# Western States Petroleum Association

Comment letter plus attachment.

Re: Comments on the Second Regional Haze Implementation Plan for 2018-2028

Figure 1. Average contribution to visibility impairment at Washington Class 1 areas (Most Impaired Days, 2014-2018)

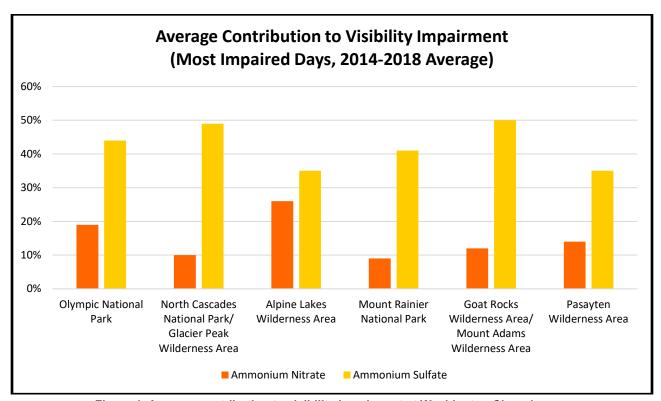
The  $2^{nd}$  draft SIP does later reference high quantities of  $NO_X$  emissions from the refineries as a reason reductions in those emissions are a focus for Ecology's four-factor review. However,  $NO_X$  emissions contribute only a small fraction to visibility impairment, and refineries represent a small fraction of the  $NO_X$  emissions in the total  $NO_X$  inventory for the state. Based on Table 3-8,  $NO_X$  emissions (in the form of nitrates) contribute only about 10% (ranging between 8% and 11%) to

visibility impairment at the nearest Class 1 area (North Cascades National Park). This small fraction compares to approximately 50% contribution from sulfates. Similar relationships of lower nitrate contribution compared to sulfate contribution also occur at all other Class 1 IMPROVE sites in the state, as presented in Figure 1 below.

Figure 2. Average Contribution to Visibility Impairment in Washington Class 1 Areas, 20% Most Impaired Days

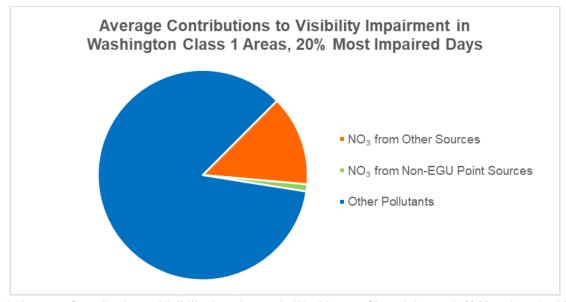
- Ammonium nitrate accounts for an average of 15% of total contribution to visibility impairment in Washington Class 1 areas (see Figure 1 above).
- WRAP model results indicate that non-EGU point sources contribute only 7% of total ammonium nitrate contributions to visibility impairment.
- This 7% non-EGU point source fraction of the 15% nitrate contribution means that NO<sub>X</sub> emissions from non-EGU point sources (including refineries and all other stationary sources in all of Washington) contribute only 1.1% to visibility impairment in Class 1 areas.

Figure 2 below, non-EGU point source NO<sub>X</sub> emissions are responsible for only 1.1% of total visibility impairment in Washington Class 1 areas.

The contributions of refinery  $NO_X$  emissions to visibility impairment represent even less than this 1.1% contribution from total non-EGU point sources. Even in the most extreme case of Ecology's SIP eliminating 100% of  $NO_X$  emissions from refineries, at less than 1.1% contribution, the change would not noticeably improve visibility in Washington's Class 1 areas. WSPA requests that the Executive Summary provide this context for the non-EGU point sources by summarizing this important insight from the WRAP model results.

Figure 3. Wind Rose for Bellingham International Airport

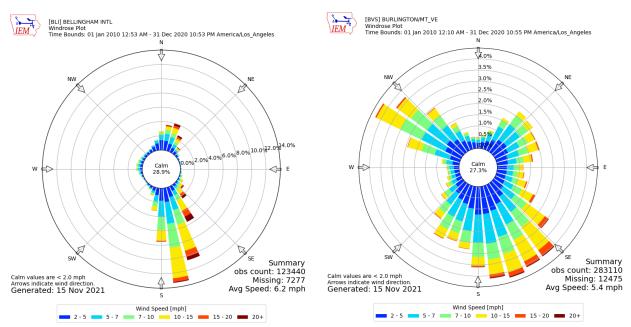
any data for the predominant wind directions observed near refineries or nearby Class 1 areas. In reviewing available wind roses in the region, the two stations in the area (Skagit Airport and Bellingham International Airport) recorded predominant winds from the south-southeast and south, respectively. The nearest Class 1 areas are generally to the east of the refineries. These 10 years of meteorological data indicate the predominant wind is **not** in the direction from the refineries towards the Class 1 Areas. Wind roses for nearby meteorological stations are provided below.

The wind roses in Figures 3 and 4 are for the Washington Automated Surface Observing Systems (ASOS) stations located nearest to the four refineries located on the north side of the state. As seen in both figures, the predominant winds in Bellingham are from the south to the north and the predominant winds at the Skagit Regional Airport are from the southeast to the northwest. In neither example do the wind roses indicate that winds would primarily travel from the refineries towards Washington's Class 1 areas, which are generally located to the east and southeast, with Olympic National Park farther to the southwest. A map of western Washington illustrating the locations of the refineries, wind roses, and Class 1 areas is provided in Attachment 2.

WSPA therefore requests that Ecology remove the statement indicating that predominant winds direct refinery emissions towards Washington's Class 1 areas (to the east or northwest). A suggested revision to this passage in the 2<sup>nd</sup> draft is provided in Attachment 1.

Figure 5. Wind Rose for McChord Airforce Base

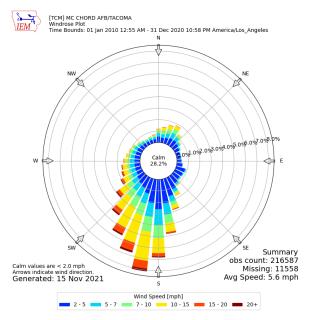
In the case of the final wind rose provided in Figure 5 below, the McChord Airforce Base ASOS station is the closest station to the U.S. Oil refinery located in Tacoma. As with the other wind roses, the predominant winds are not in the direction from the refinery towards the Class 1 areas, but rather from the south to the north. The predominant winds in all cases indicate emissions from refineries are infrequently travelling toward Class 1 areas. The limited expected impact of the U.S. Oil refinery in particular is further supported by the site's Q/d screening ratio of 3.21. The U.S. Oil refinery has a Q/d ratio of less than one third of the threshold used by Ecology for source selection. The screening results alone indicate that U.S. Oil does not have an expected impact on visibility impairment at Class 1 areas that warrants inclusion in the draft SIP.

Figure 6. Capital Cost Comparison Between EPA Control Cost Manual and Revised SCAQMD Model (SCAQMD, 2021, red line annotation added)

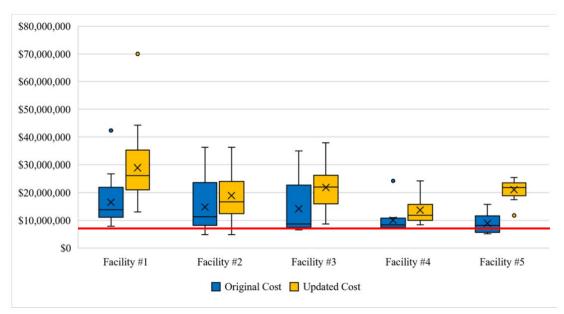
Ecology for each of the heaters and boilers considered in the 2<sup>nd</sup> draft SIP (\$6,750,635). As illustrated in the figure, Ecology's preliminary cost estimates are below even the SCAQMD initial estimates that used the existing EPA Control Cost Manual When compared to the refined costs using the revised model that was accepted by SCAQMD for the final rulemaking, the comparison shows that Ecology's preliminary cost estimates vastly under-estimated the actual costs of SCR implementation on refinery boilers and heaters.

WSPA recognizes that there are notable differences in circumstances between Southern California and Washington that will necessitate a deeper review of the revised cost model. The cost effectiveness values for the SCAQMD rulemaking are not directly comparable to the cost effectiveness values under regional haze because the two programs have different goals and also because the two programs use difference cost bases. The SCAQMD cost effectiveness values are determined using the discounted cash flow (DCF) method.<sup>8</sup> The EPA Control Cost Manual, in contrast, uses the equivalent uniform annual cash flow (EUAC) approach.<sup>9</sup> While the regulatory context for these costs is different and means the final cost effectiveness values are not directly comparable to those calculated for the Washington's Regional Haze program, the refined SCAQMD model's capital costs are appropriate to compare. The SCAQMD model and associated capital costs can serve as a helpful reference point for reasonable capital costs and a strong starting point for future cost calculation discussions.<sup>10</sup>

WSPA believes that focusing future collaboration with Ecology on models such as the one developed for SCAQMD can ensure that more accurate cost estimates for SCR are developed that appropriately account for refinery operations.
